Title: Advisory Committee on Nuclear Waste
173rd Meeting

Date: Thursday, September 21, 2006

29) Disposition of Public Comments on Spent 5

Baltimore and Caldecott Tunnel Fire Studies Response to Comments

Possible Locations of Spent Fuel Casks based on DOT Regulations

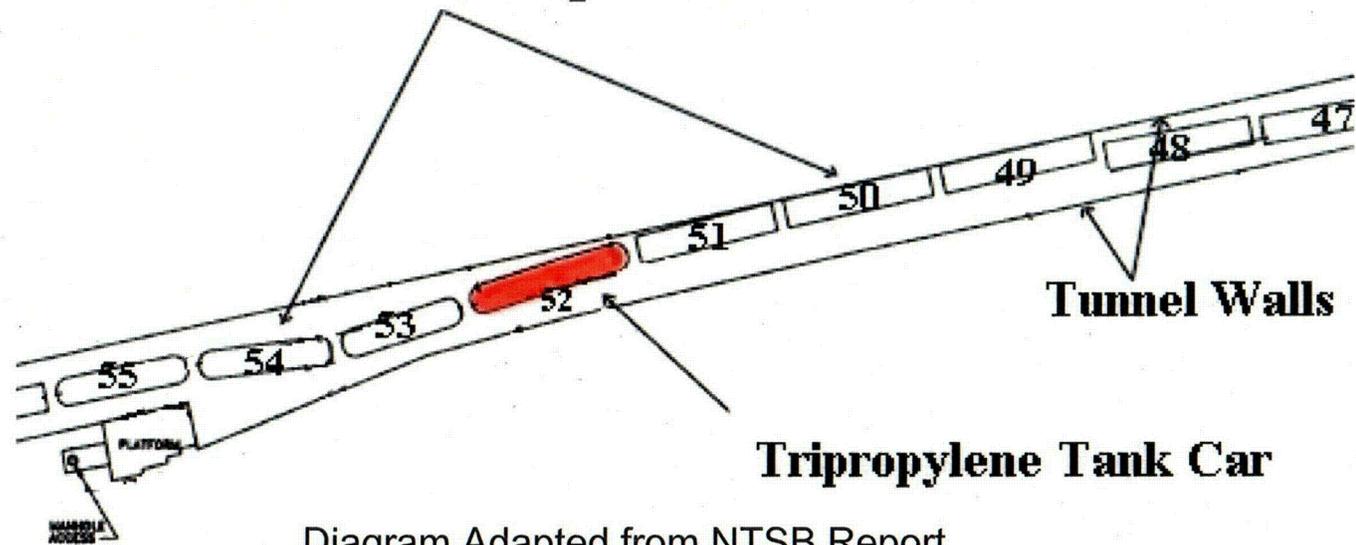
13 The first area that I am going to address
14 is the location, intensity, and duration of fire.
15 Comments basically were, did you put the cask close
16 enough to the fire? Would it have been worse had you
17 have placed the cask closer to the tank car?

11 When you apply that, when you look at what
12 really happened at the tunnel -- and this diagram in
13 the upper left-hand corner is modified from the
14 National Transportation Safety Board report, but this
15 is a sketch -- cars 47 through 55 derailed. Car 52
16 was the tripropylene tank car.

17 So had theoretically a spent fuel cask
18 been in that manifest for that train, it would have
19 been perhaps in site 54 or site 50 with 51 and 53
20 being the buffer cars. Okay?

1 trains. They have a regulation -- it's 49 CFR 174.85
2 -- that requires a non-placarded, nonhazardous car to
3 intervene between spent fuel casks and any other class
4 of hazard, such as flammable liquid.

DOT requires that radioactive materials be separated by buffer cars from other hazardous materials (49 CFR174.85)

Location of Spent Fuel Casks

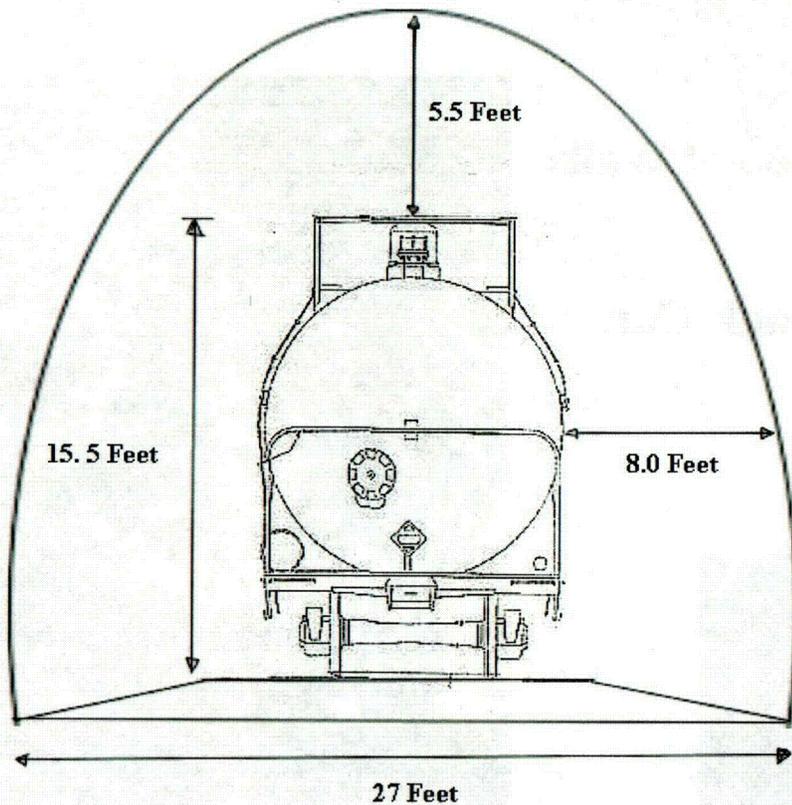
21 Could you have gotten the tank car closer?
22 Well, if you look at a schematic of the tunnel looking
23 end on, you see that there is not really much room to
24 go around a tank car. And there's not really much
25 room, really, to go override a tank car for the --

Top View

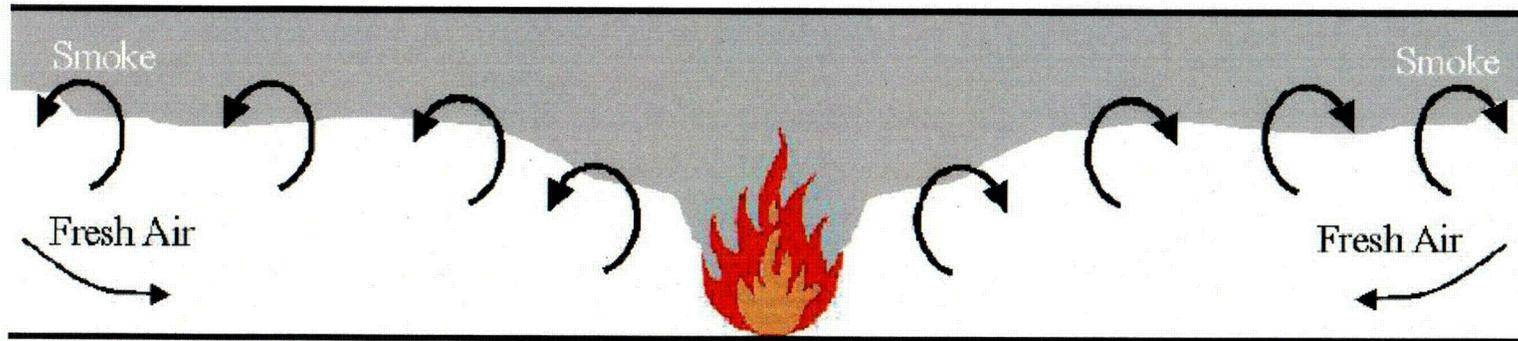
2 If you look top view, we have 3 rail cars
3 basically 60 feet -- dueling lasers here. We have 3
4 rail cars roughly 60 feet in length. The tunnel is
5 about 15 feet. And even if you try to squeeze them
6 together, you don't really get much closer. So we
7 think, really, what this indicates is the
8 effectiveness of the DOT rule. This is, indeed, why
9 the rule was implemented.

Fire Intensity

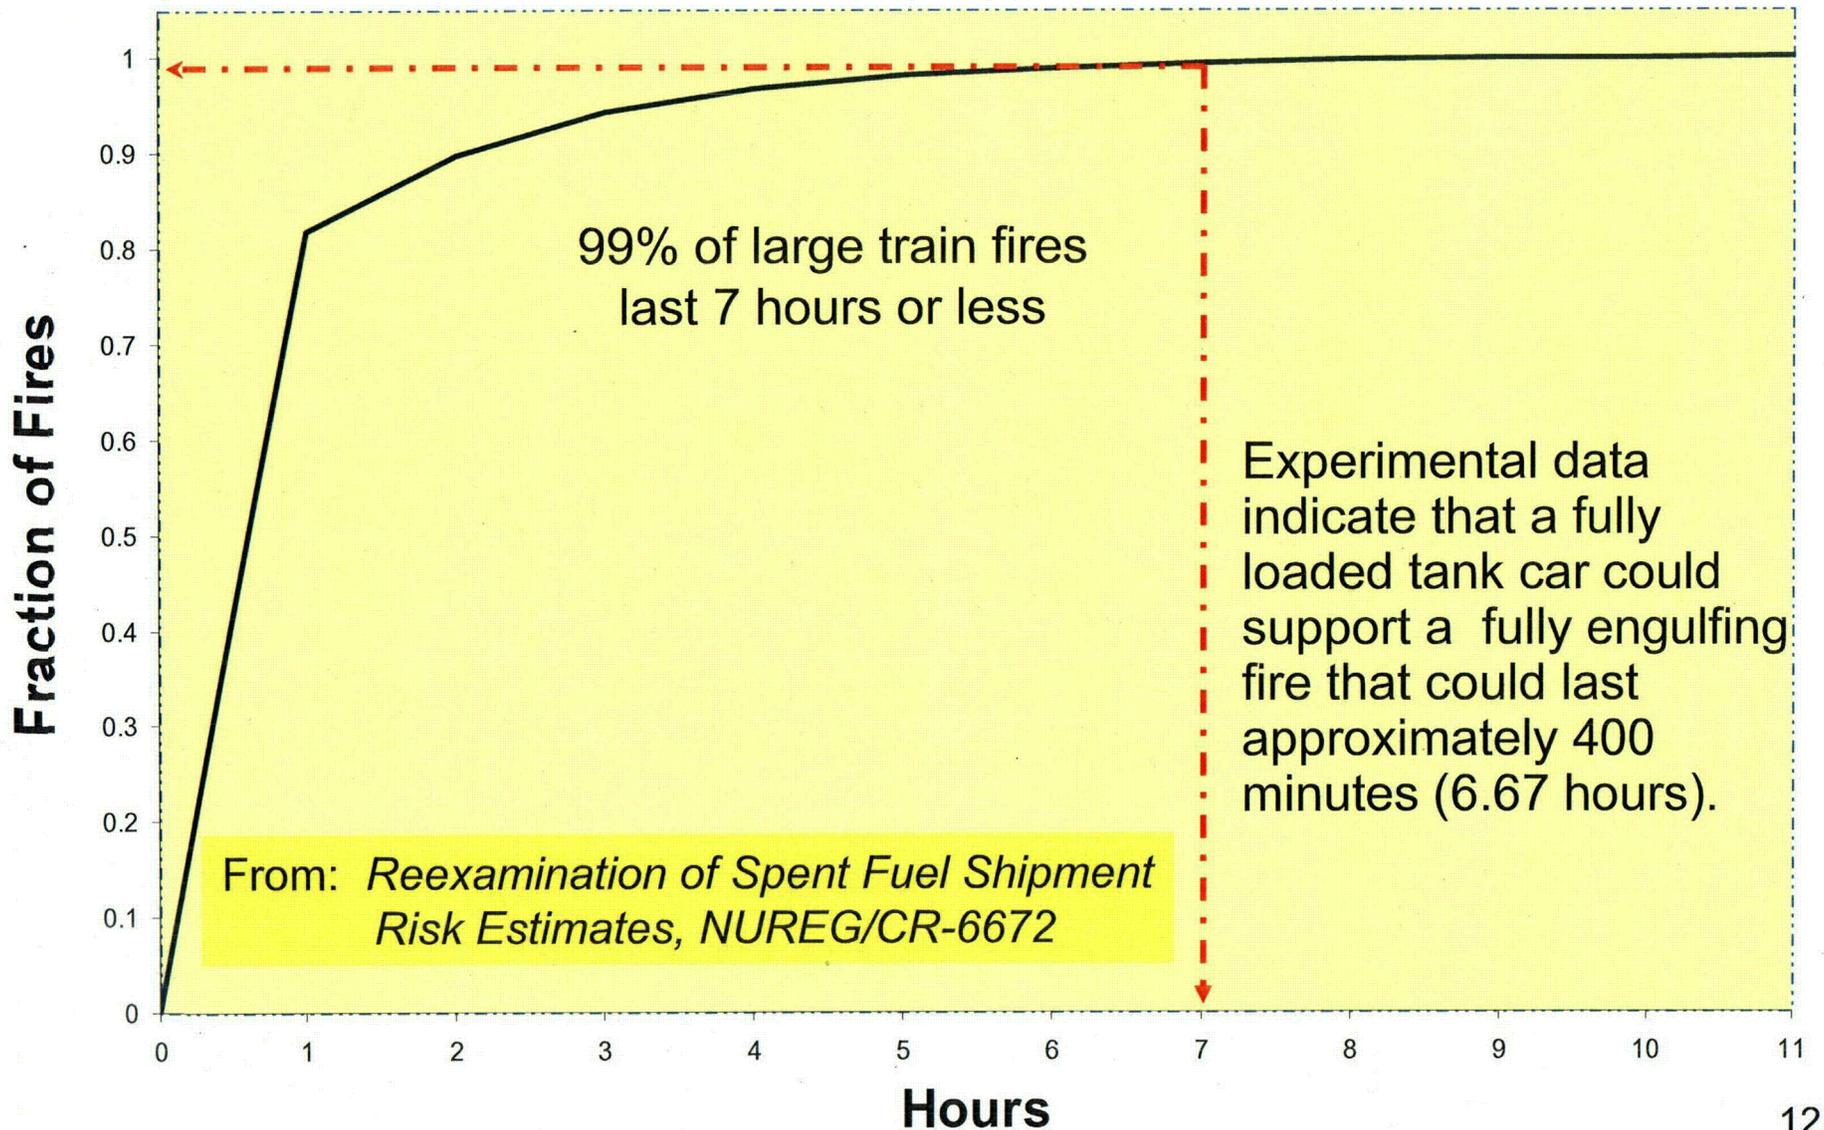
15 CHAIRMAN RYAN: Let me ask you a question.
16 How is it realistic if it's ten times more the
17 realistic envisions? It's a bounding case.

24 CHAIRMAN RYAN: And, yet, you assumed ten
25 times higher. So some of the specificity that you

14 CHAIRMAN RYAN: It does. Does the
15 document explain the basis for the factor of ten?

21 MR. ADKINS: Actually, we have added
22 verbiage over that. Harold Adkins from PNNL.

23 We have gone ahead and added verbiage to
24 the document that explains the fact that it could have
25 been a tunnel that involves ventilation, like current

- NIST analysis of the actual fire predicts
 - Intensity to be no more than 1.7×10^8 Btu/hr (50 MW).
 - Fire is oxygen starved.

- Peak temperatures of 1832 – 2010 °F in flame region.
- Hottest temperatures occur within first hour.
 - Peak ceiling temperature at source - 1472 °F
 - Peak ceiling temperature at cask - 752 °F

Modeling of Lead Melt (ACNW Comment)

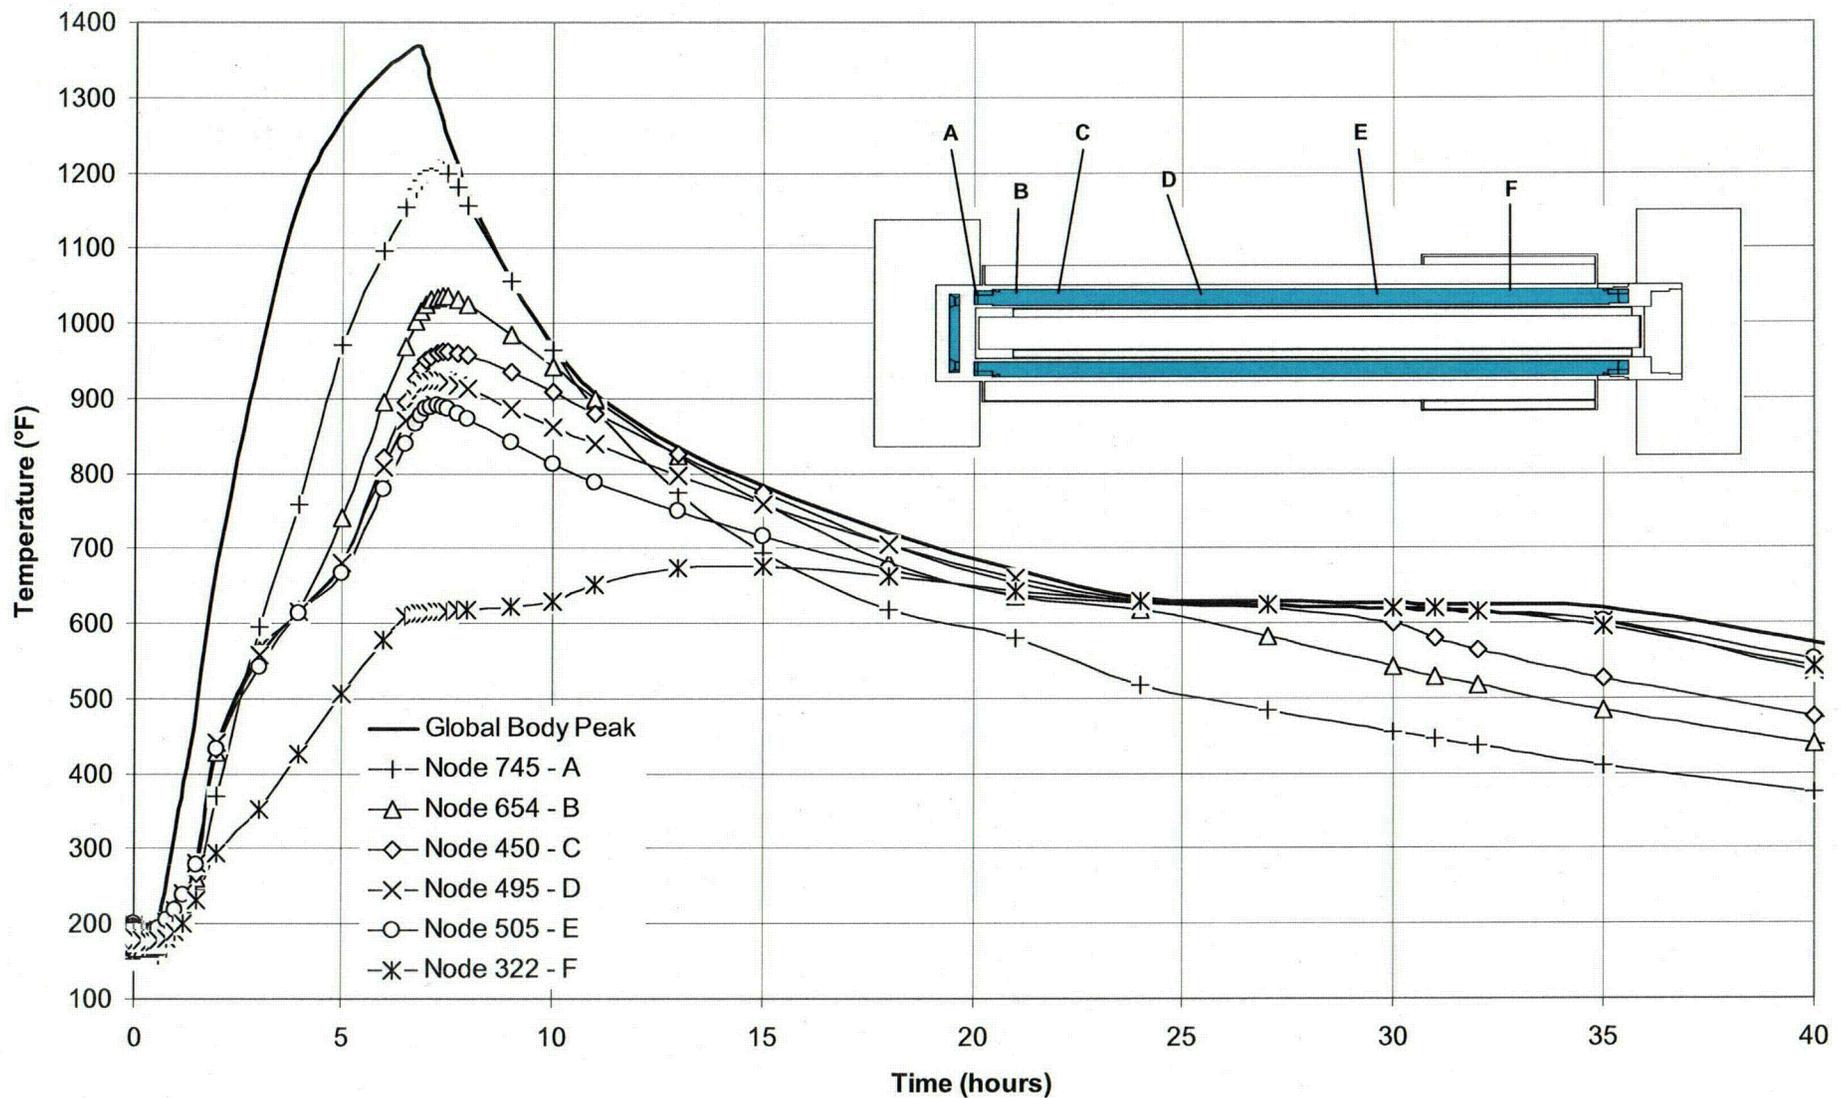
4 One of the comments issued by the ACNW is
5 that within the reports of Baltimore and the analysis,
6 of course, Baltimore and Caldecott tunnel fire
7 studies, we didn't consider lead melt and that not
8 modeling of lead melt could affect the outcome of the
9 analyses in two ways. For one, it would yield
10 non-conservative results from the shielding standpoint
11 if you had lead slump and then an extra-conservative
12 result from the perspective of internal temperatures
13 within the cask.

- The Baltimore and Caldecott Tunnel Fire Studies did not consider lead melt. Not modeling lead melt could effect the outcome of the analyses.

14 We went ahead and updated. To address
15 this question, we went ahead and updated the model of
16 the LWT and to include the effect of lead melt.

17 What we have here, just to show, I guess,
18 that we have the latent heat effusion taken into
19 account is when you consider different points along
20 the cask as a function of time as it approaches, as we
21 consider locations where there's a little larger lead
22 volume, going across the cask to points where there is
23 also somewhat of an insulative barrier after the
24 neutron shield ruptures, we get an arrangement where
25 basically the temperatures rise, plateau, plateau off,

Activity Density for Major Isotopes for PWR Assemblies with Maximum CRUD Spot Activities

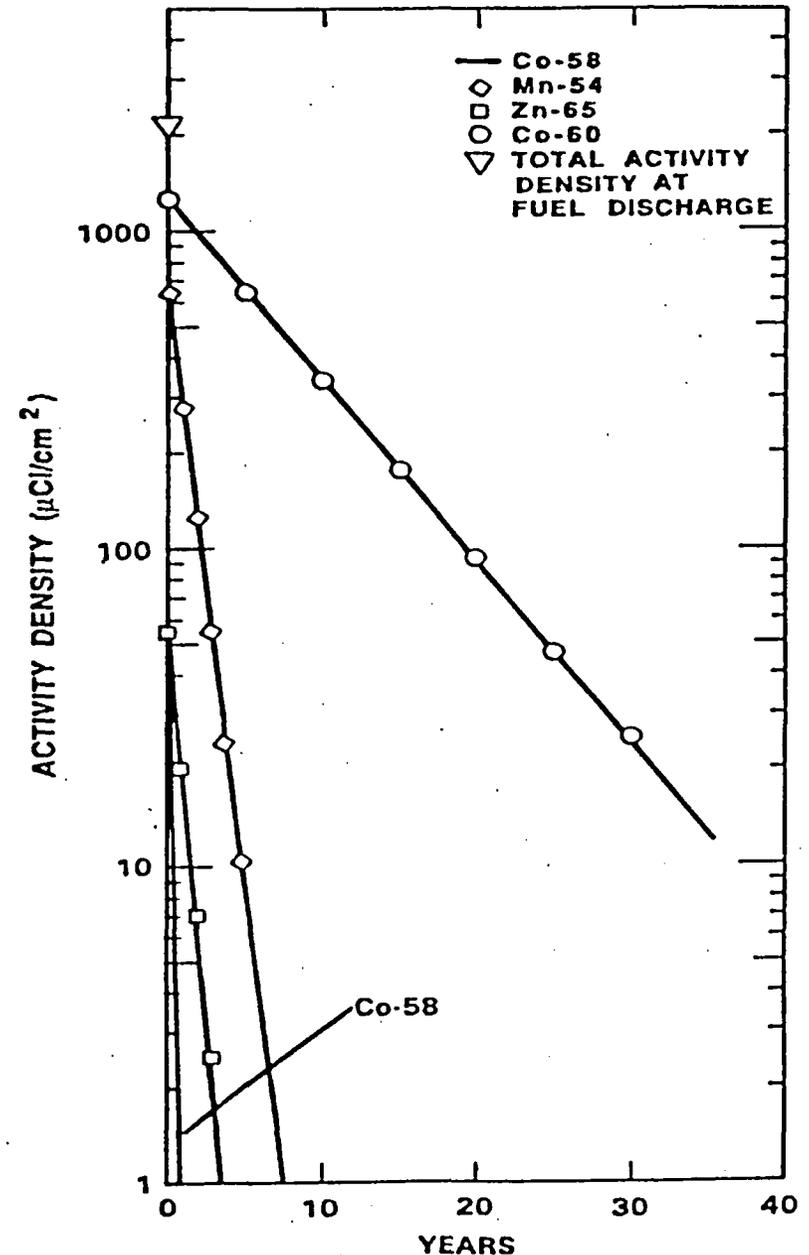
13 One of the questions that we had from the
14 ACNW was about the assumption that we made that 100
15 percent of the CRUD that can come off the fuel rods
16 was cobalt-60, that that was the main radionuclide
17 constituent of the CRUD. And the question is, is that
18 a valid proximation? And how would it affect the
19 doses in this case of any particular release?

- The Baltimore and Caldecott Tunnel Fire Studies assumed that the composition of CRUD on the fuel rods was 100 % Co-60. Is this a valid approximation and how would it affect doses?

- Total activity decreases to 3% of that at discharge after 5 years and to 1% after 13 years.
- Cobalt-60 accounts for 92% of the activity at 5 years and 99% at 8 years.

Potential Doses with Loss of Lead Shielding

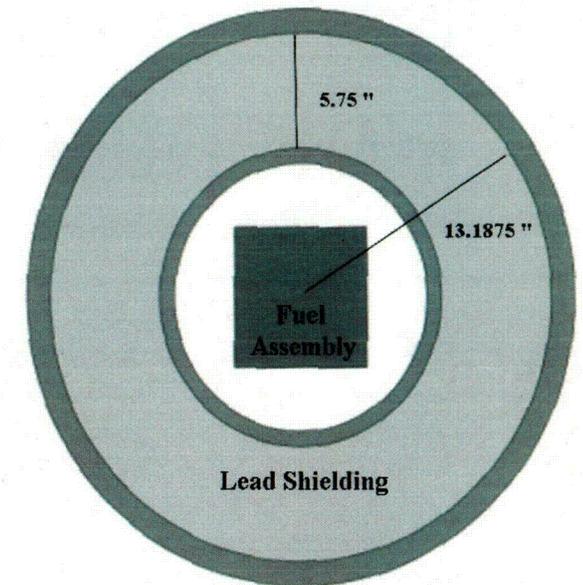
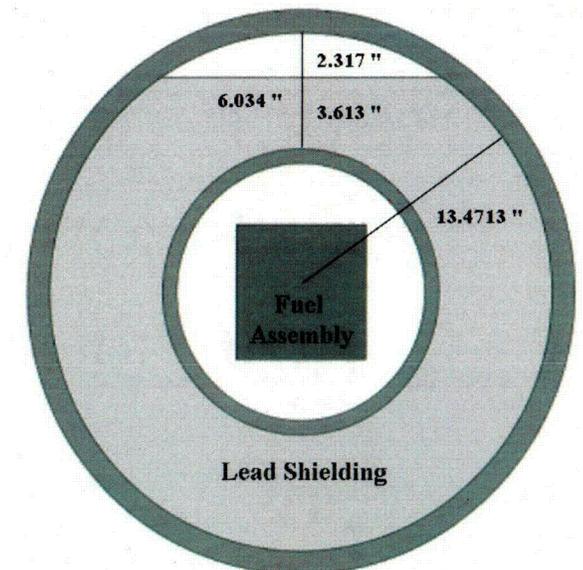
Potential Loss of Lead Shielding (Public Comment)

1 lead melt and resolidification, that the doses would
2 remain below the regulatory limits for hypothetical
3 accident conditioned under Part 71. And we have
4 revised the report to reflect that.

- Doses remain below regulatory limits for any probable loss of shielding due to lead melt.
- Report has been revised to include discussion and diagrams of staff analysis of potential shielding loss.
